## Discretionary Review Abbreviated Analysis

*Date:* January 11, 2016  
*Case No.:* **2015-003768DRP**  
*Project Address:* **2462 Filbert Street**  
*Permit Application:* 2015.03.25.1848  
*Zoning:* RH-1 (Residential House, One-Family)  
40-X Height and Bulk District  
*Block/Lot:* 0513/009B  
*Project Sponsor:* Federico Engel  
Butler Armsden Architects  
First Floor, 1420 Sutter Street  
San Francisco, CA 94109  
*Staff Contact:* Brittany Bendix – (415) 575-9114  
brittany.bendix@sfgov.org  
*Recommendation:* **Do not take DR and approve as proposed**

Discretionary Review Hearing  
Case Number 2015-003768DRP  
2462 Filbert Street

**Re: 2462 Filbert Street (0513/009B)**  
**Brief in Opposition to Discretionary Review Request**  
**Planning Department Case No. 2015-003768DRP**  
**Hearing Date: January 21, 2016**  
**Our File No.: 8997.01**

View from 2475 Filbert

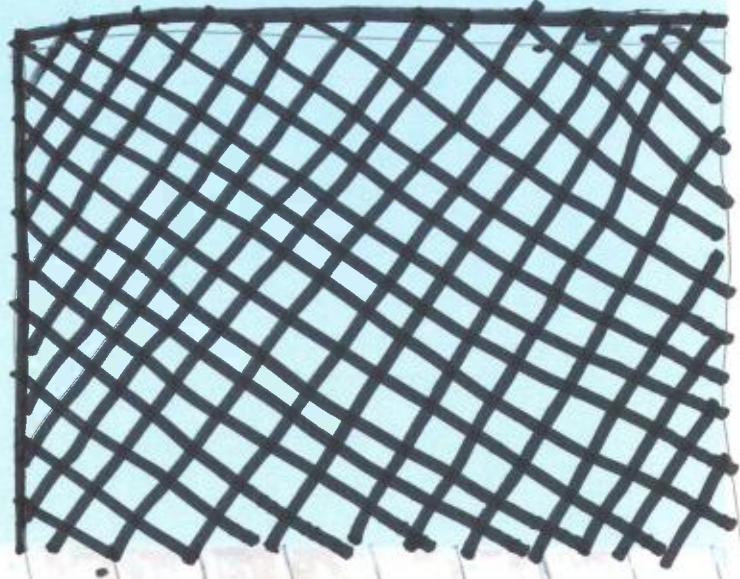
NEW CONSTRUCTION  
WEST DOOR

STREET VIEW OF  
ELEVATOR BOX

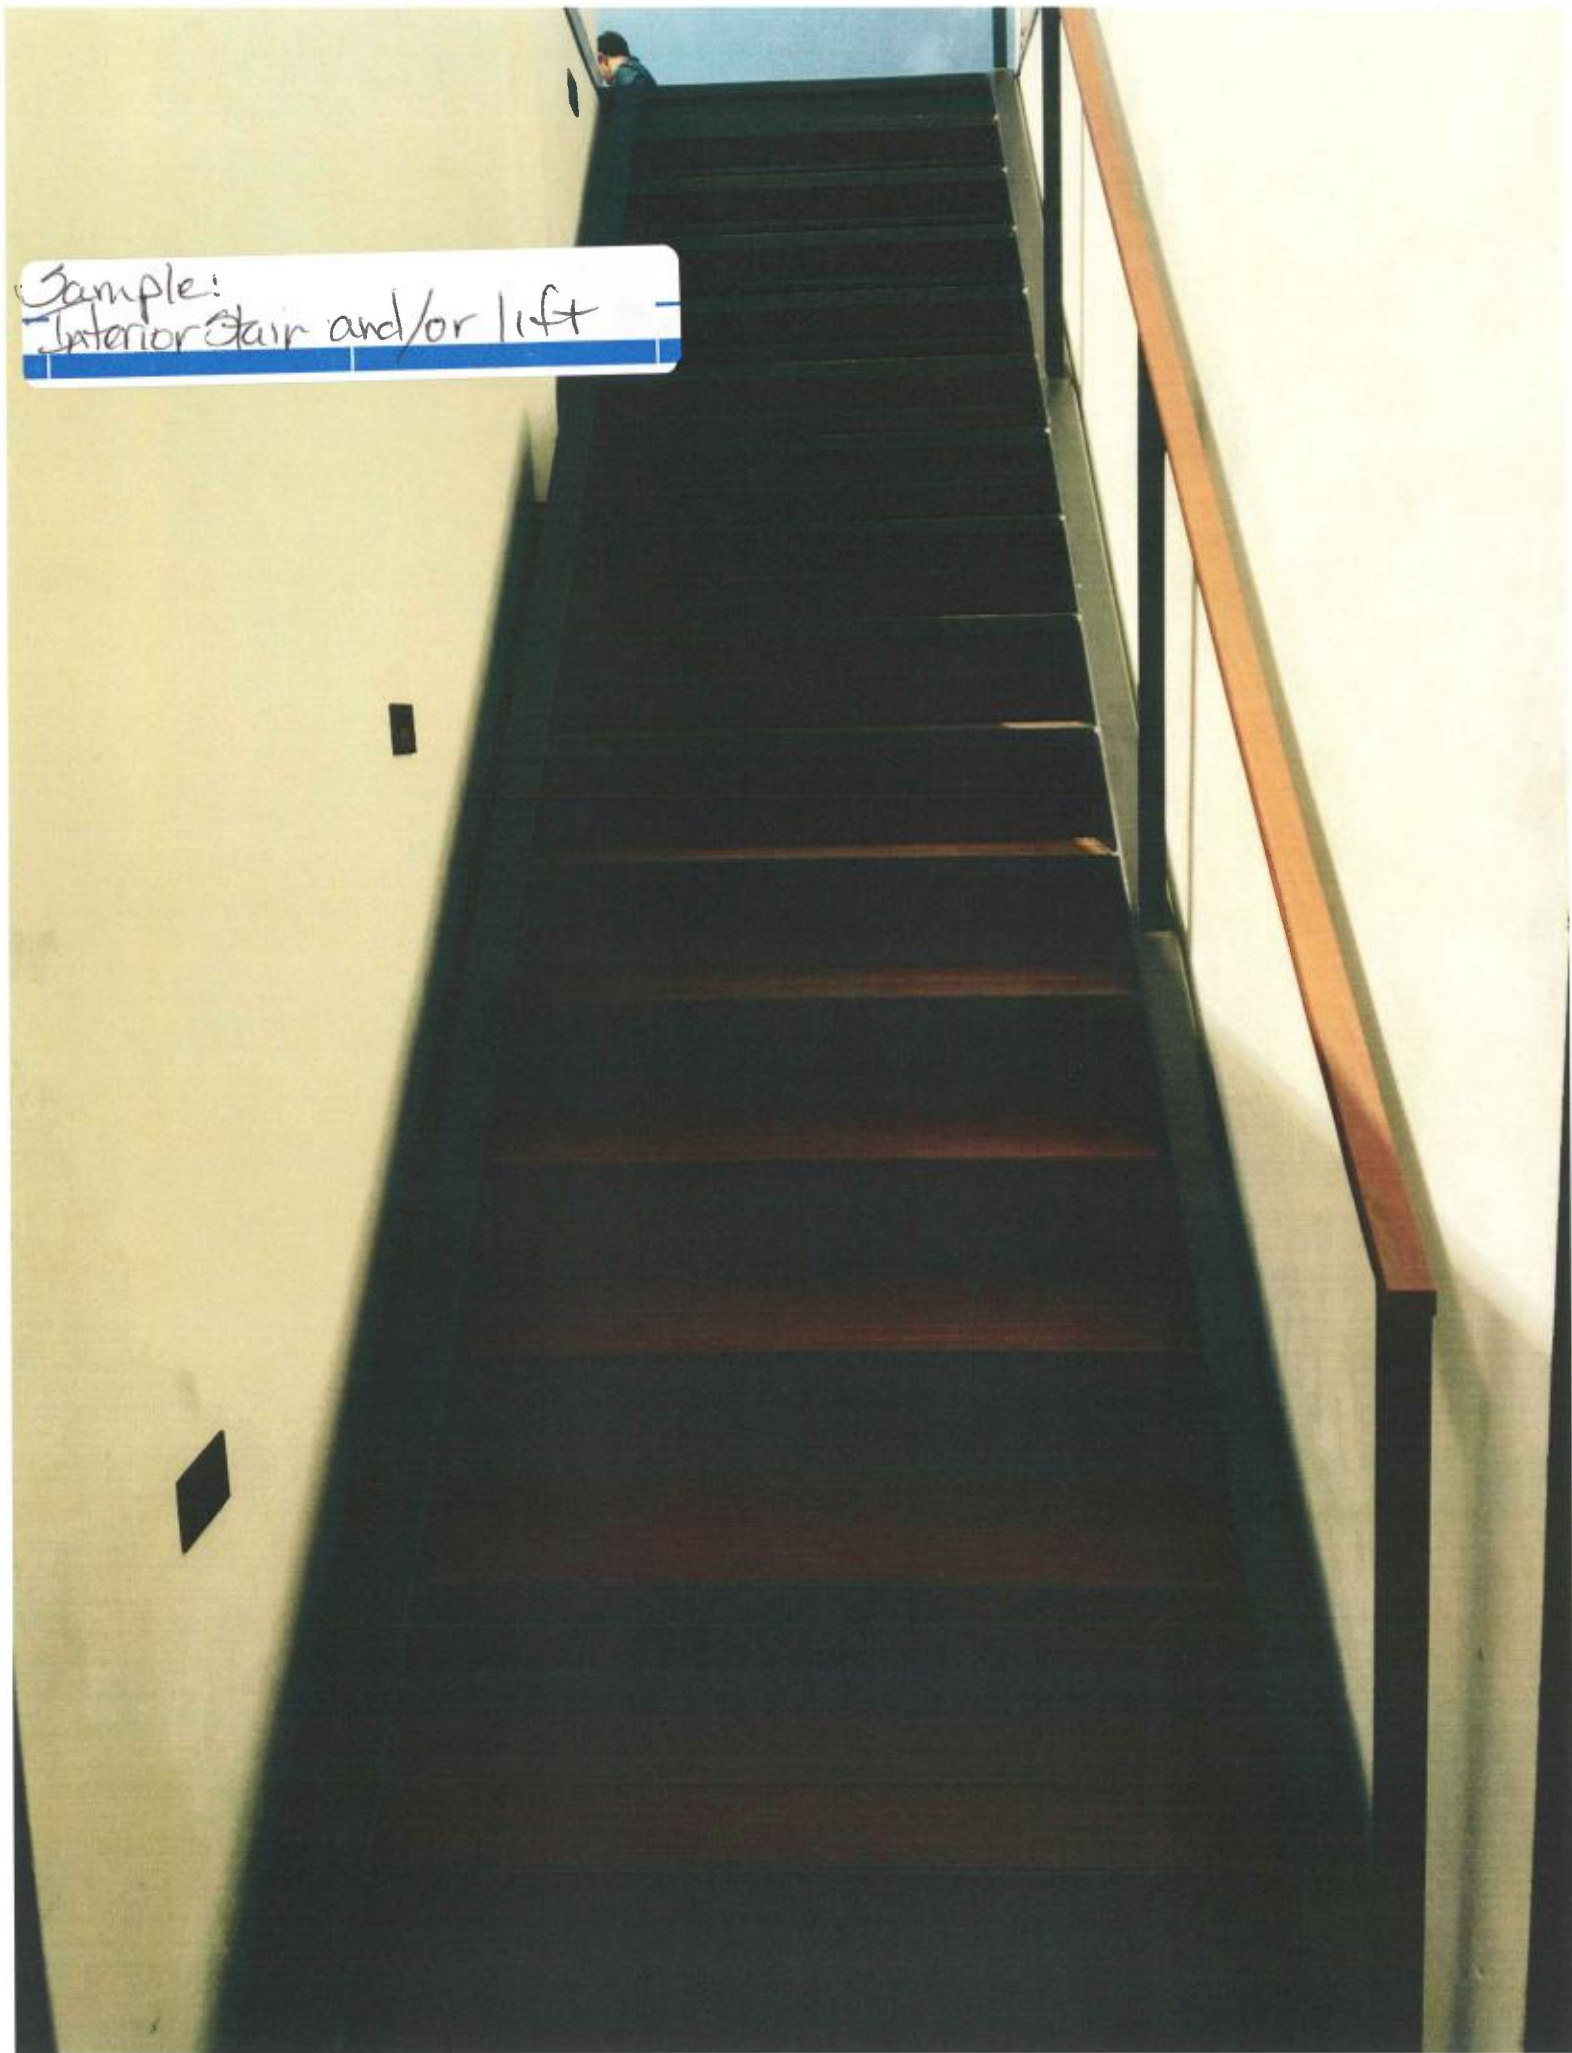
# 3. Alternatives or Changes in Response to Adverse Affects: Exhibit 5

\* Applicant has recently been awarded a Variance by the Planning Department to extend the back of the structure and add an exterior staircase to the roof deck.

\* Should health issues arise with a desire to access the roof, an interior staircase lift could easily be added in the future. (See Exhibit photo of interior stairs).

PHOTO C

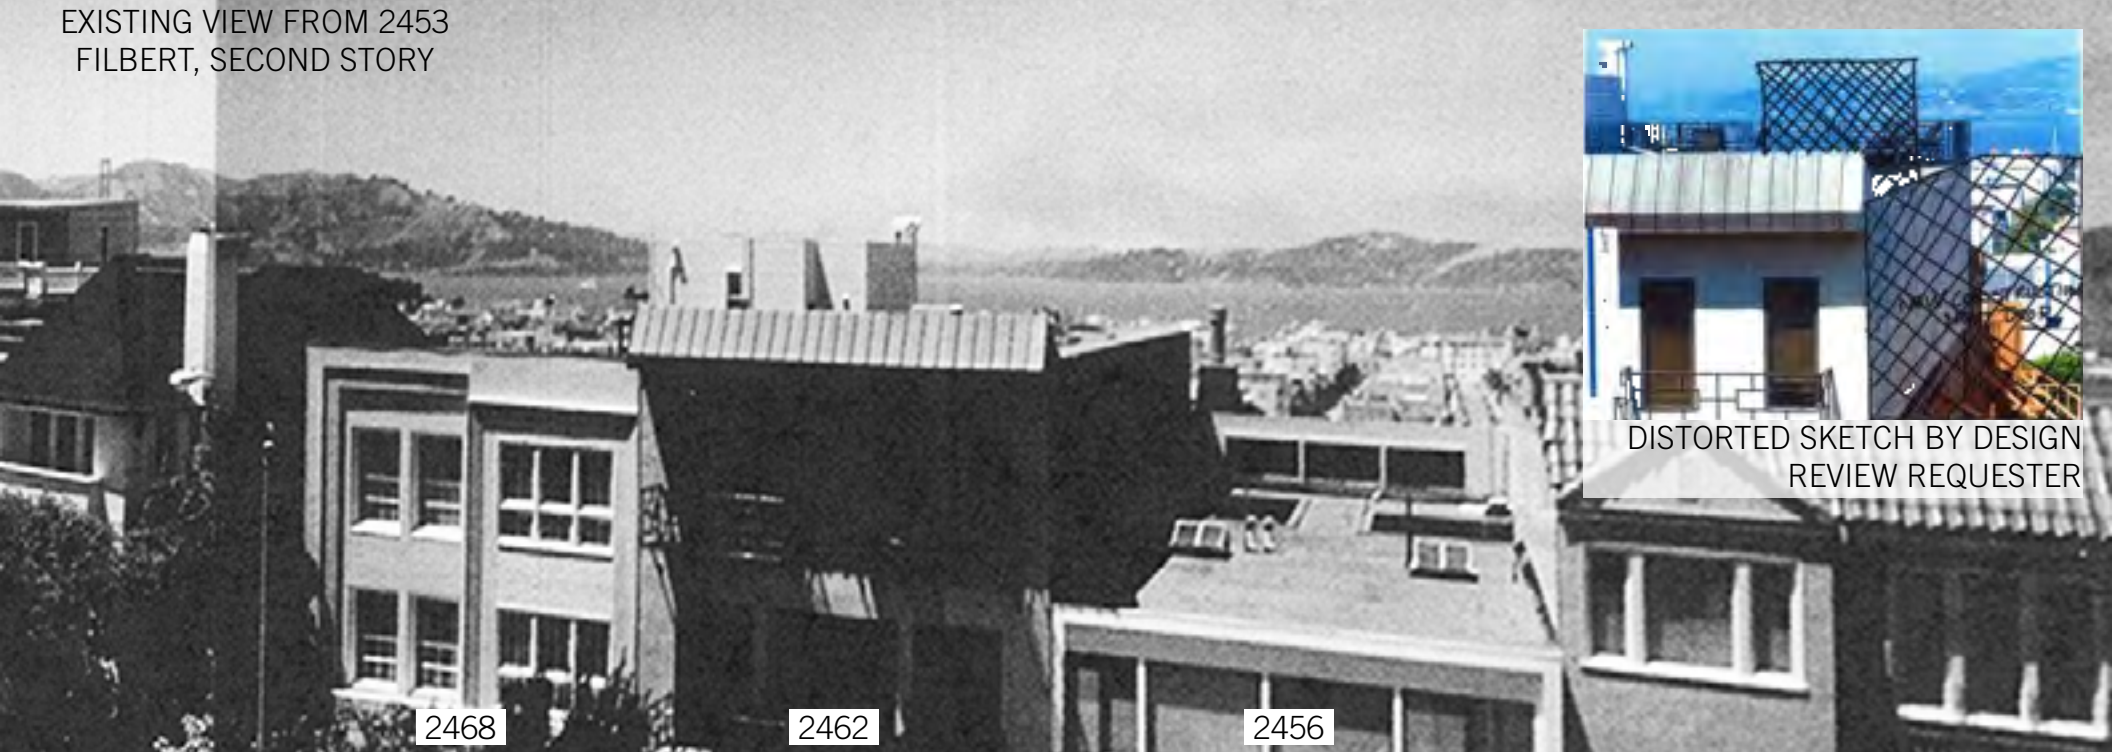
Moreover, in an attempt to show alleged incompatibility with neighborhood character, the DR requester submitted renderings of the proposed penthouse to Planning Department Staff that are grossly distorted and misleading. Those renderings are shown in **Exhibit C**.

DISTORTED SKETCH BY DESIGN  
REVIEW REQUESTER

In contrast, we have provided accurate renderings of the penthouse attached as **Exhibit C**. Views "B" and "E" show that the penthouse will not be visible from Filbert Street after the new construction is completed at the adjacent property (2456 Filbert Street).. Views "C", "D" and "F" show that the penthouse is scarcely visible.
